ERIE
COLORADO

Westerly Preliminary Plat No. 3

Town Council

Aly Burkhalter, Senior Planner

Oil & Gas

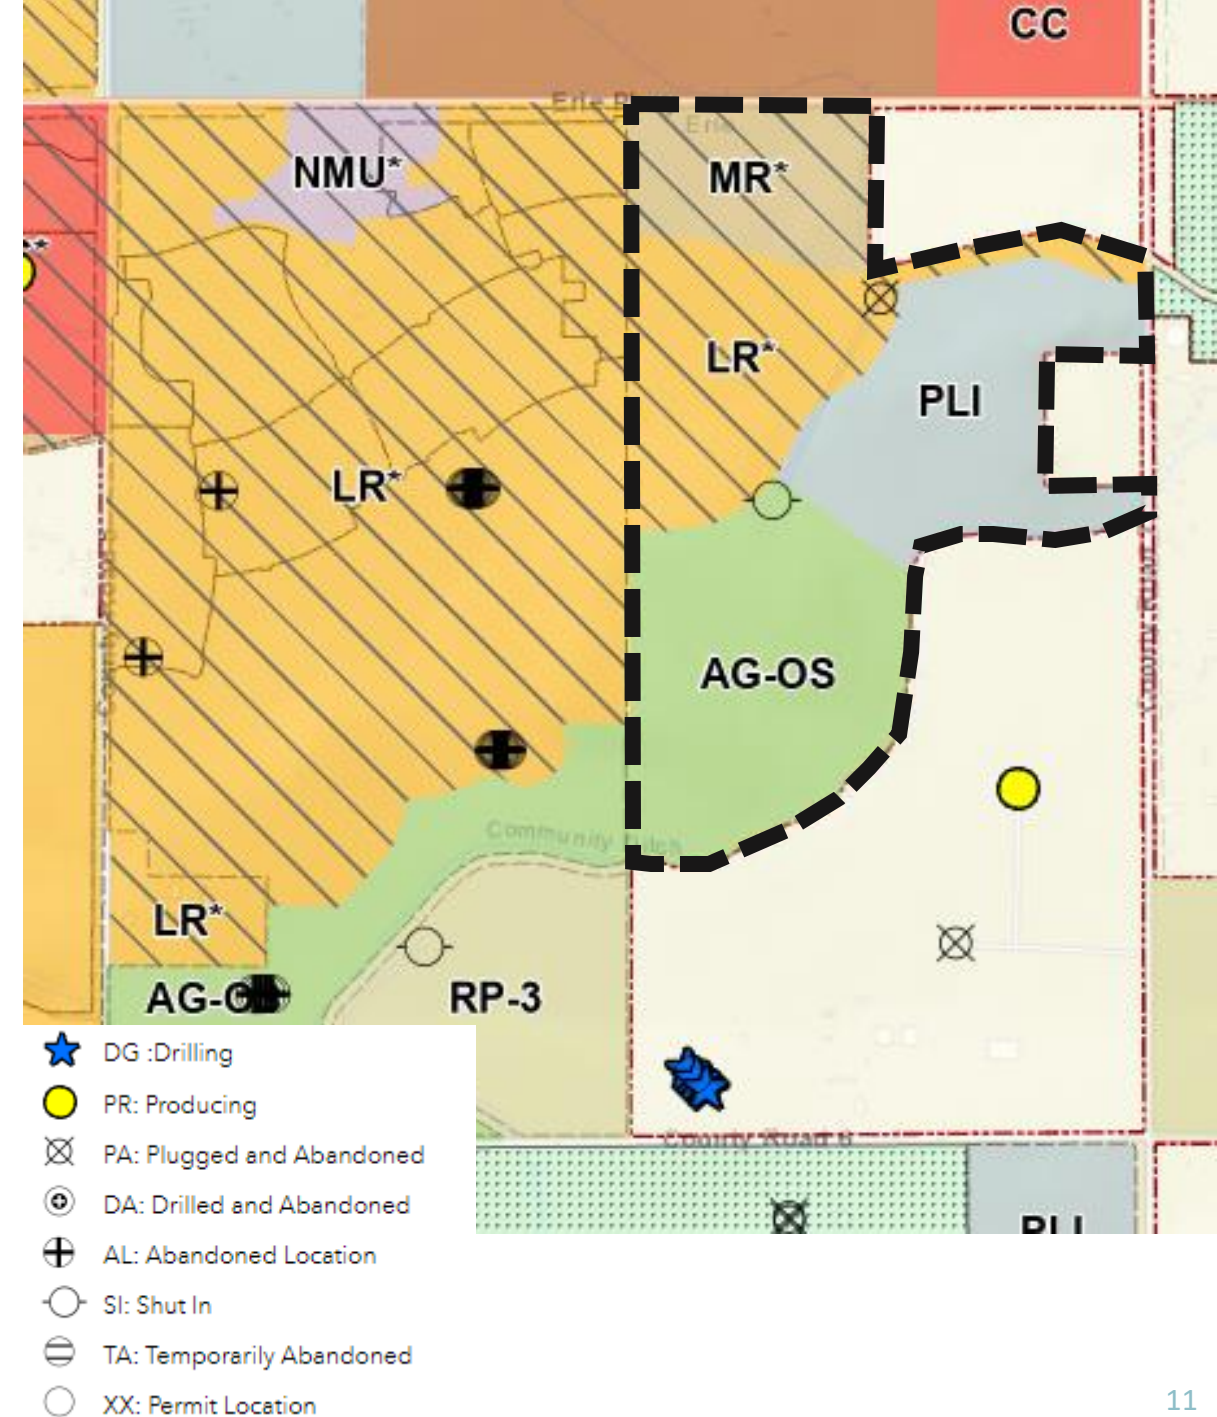
- 25' setback from P&A wells
- 150' setback from streets and trails
- 350' buffer from well sites to residential lots, non-res. buildings, parks

Environmental Hazards

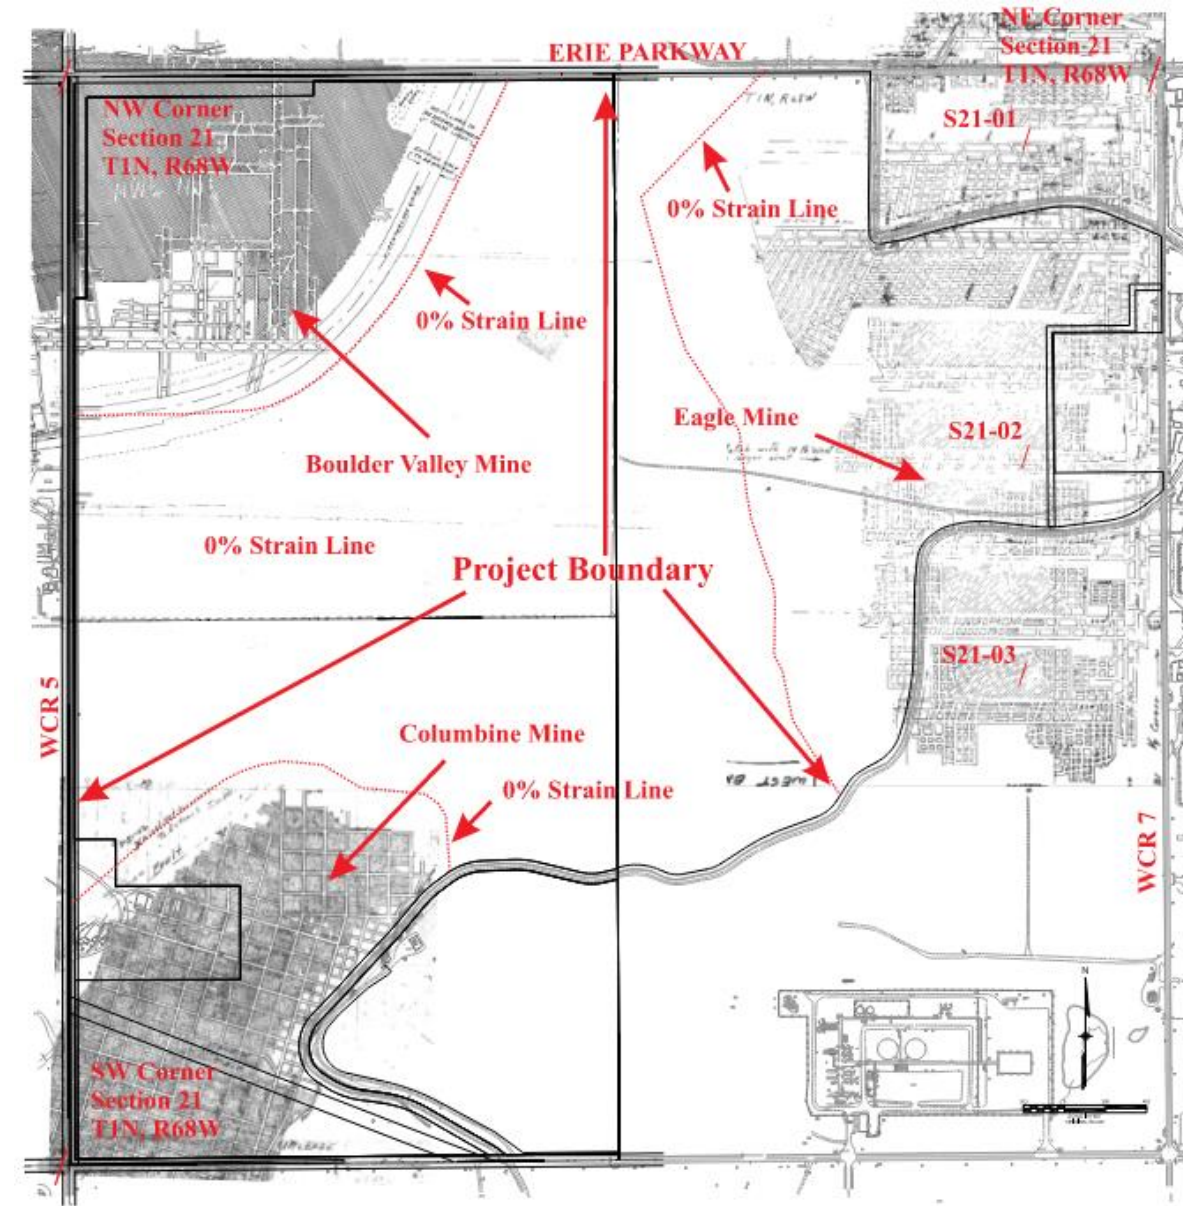
- Eagle Mine is present, but at depths not considered to impact residential development.
- Further analysis may be needed for the school.

Preliminary Plat – Transportation and Access

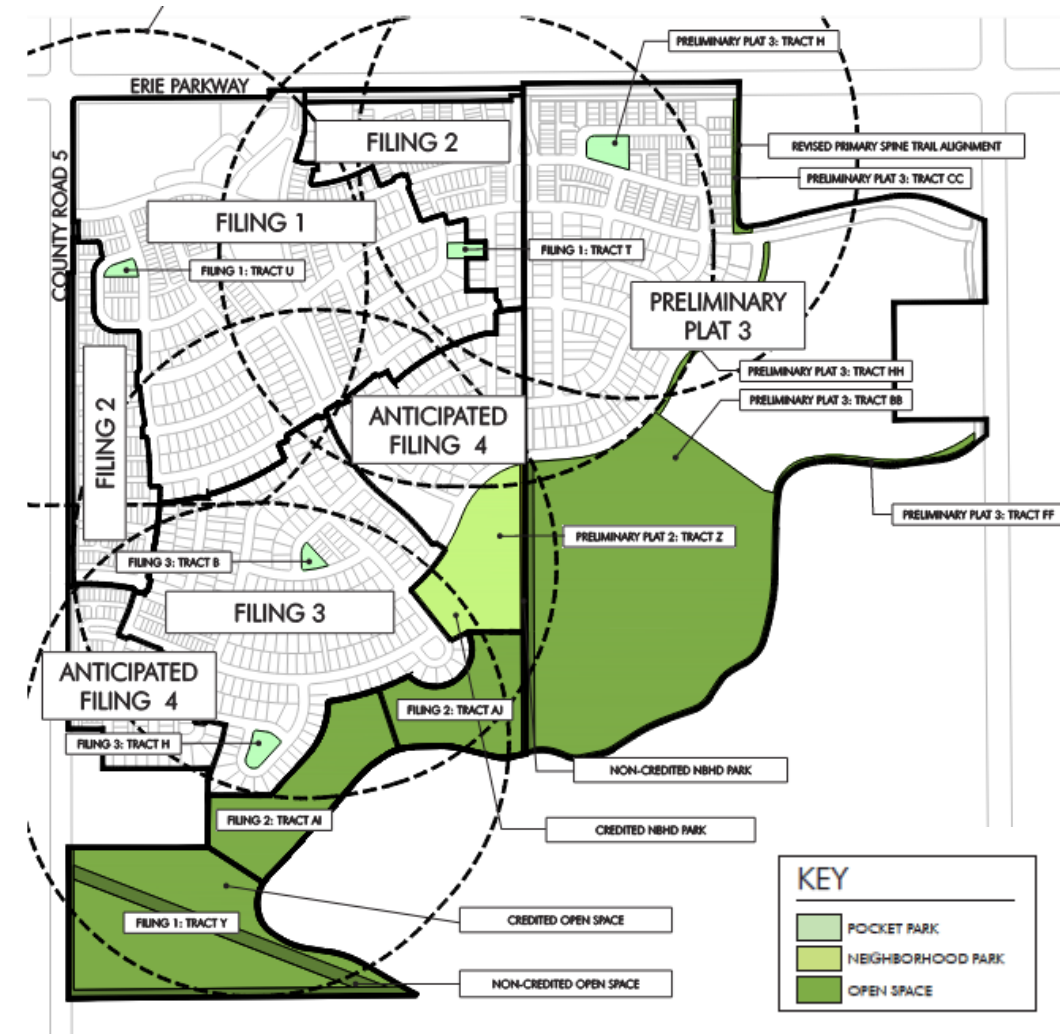
New internal network of public streets, trails and sidewalks through ROW dedication and public access easements

Overall access from Erie Parkway and WCR 7

- Erie Parkway
 - Widening to 4-lanes with 18' median
 - Signalized intersection at Waterford Street and WCR 7
- WCR 7
 - Stop sign controlled with northbound left turn lane onto Chestnut and right turn lane from Chestnut to WCR 7

Preliminary Plat - Schools

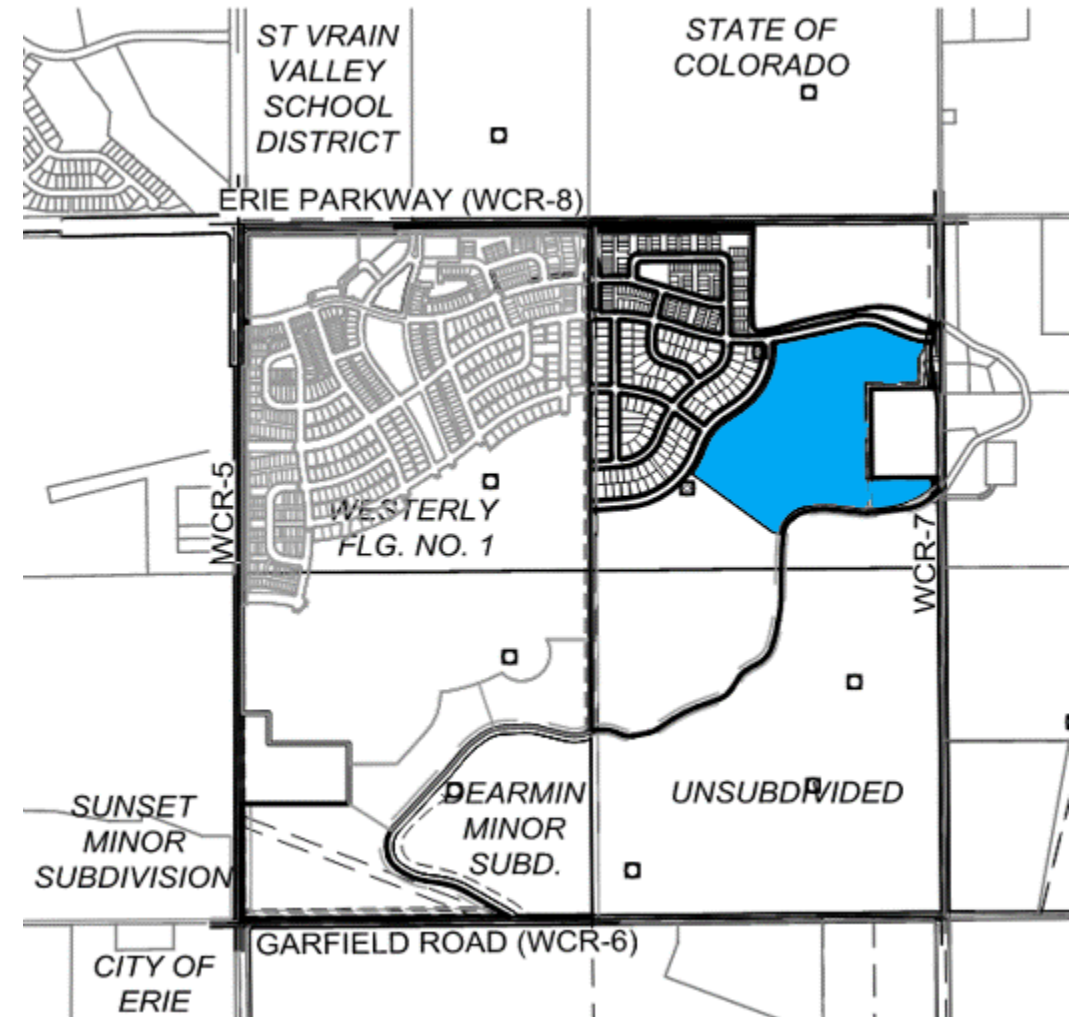
- Tract AA to be dedicated as future SVVSD school
